ADDENDUM

PROJECT: Lincoln Public Schools
Security and Technology Ready Facilities
Project H
Lincoln, Nebraska

AD-1

PROJECT #: DDI No. 14-0077 / LPS Bid No. 7636-H

From Sheet:	303.T00.G	for CA use:
Drawing #	303.T00.G.2

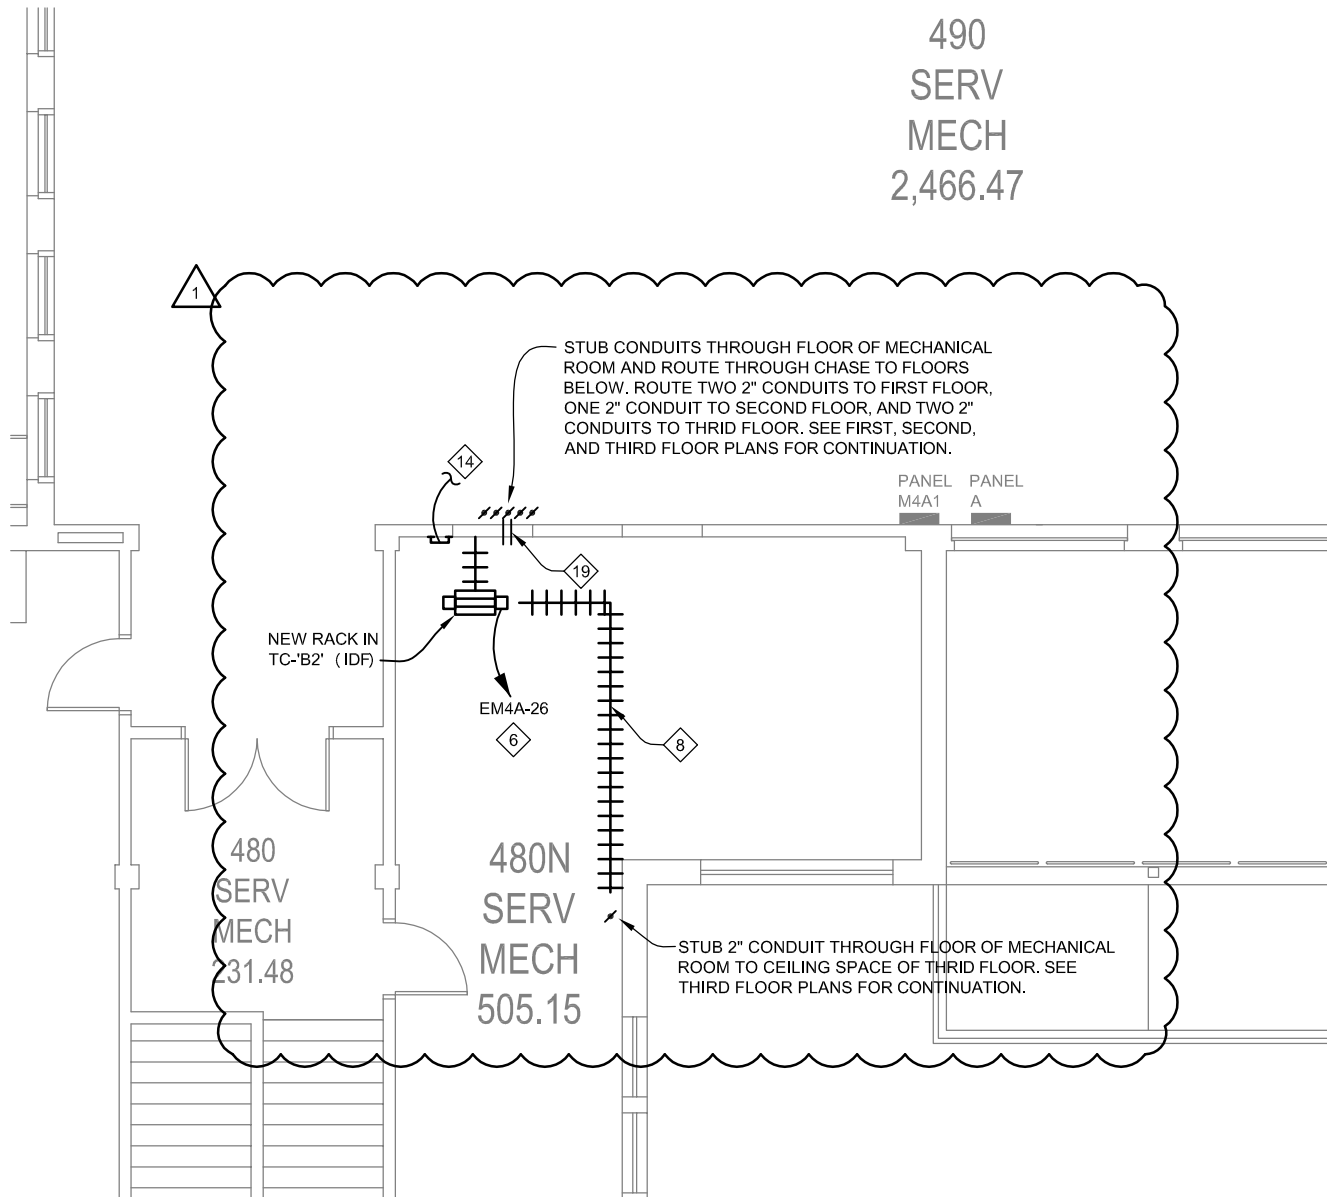
In reference to Sheet 303.T00.G, see attached sketch 303.T00.G.1 and 303.T00.G.2 for revisions.

From Sheet: 303.T04.A	for CA use:
Drawing # 303.T04.A.1

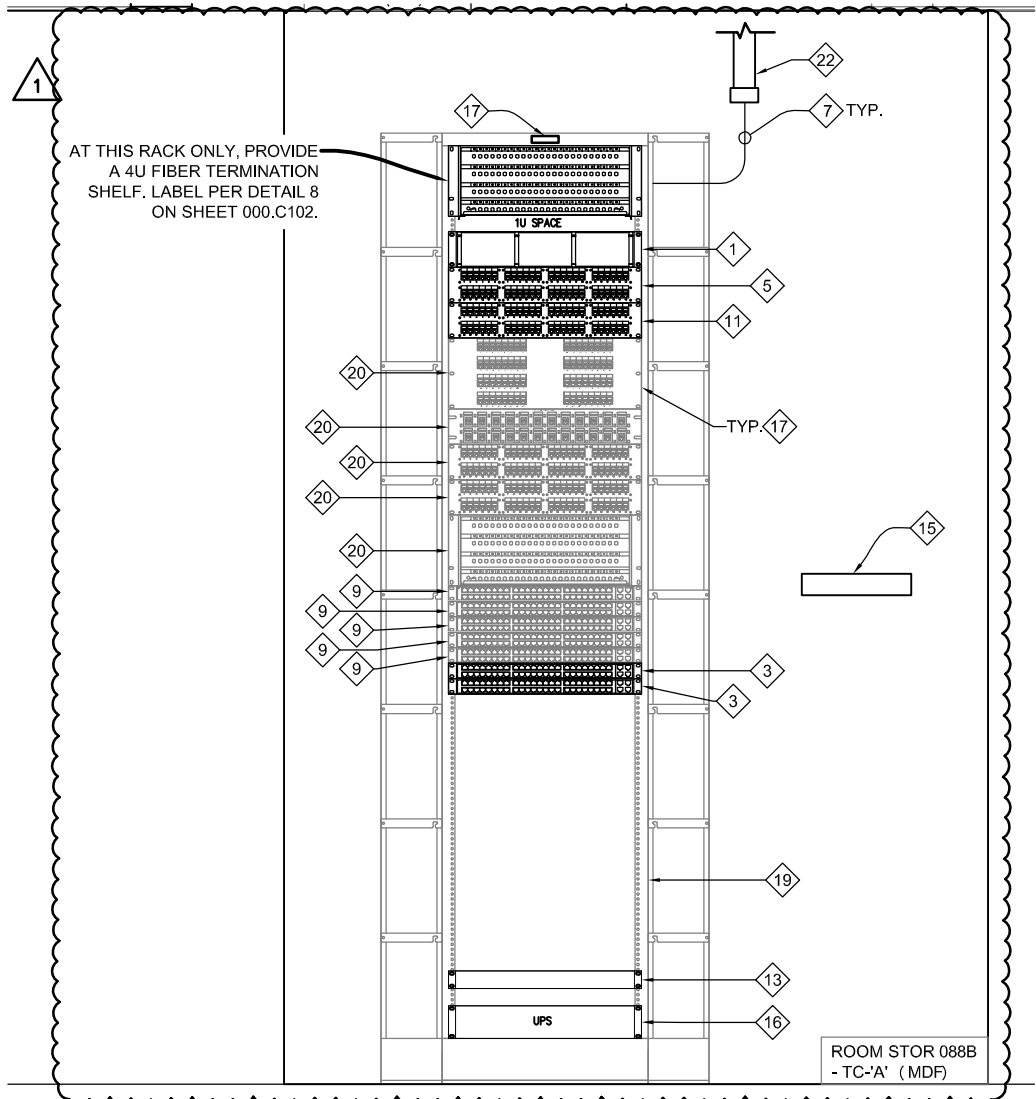
In reference to Sheet 303.T04.A, see attached sketch 303.T04.A.1 for revisions.
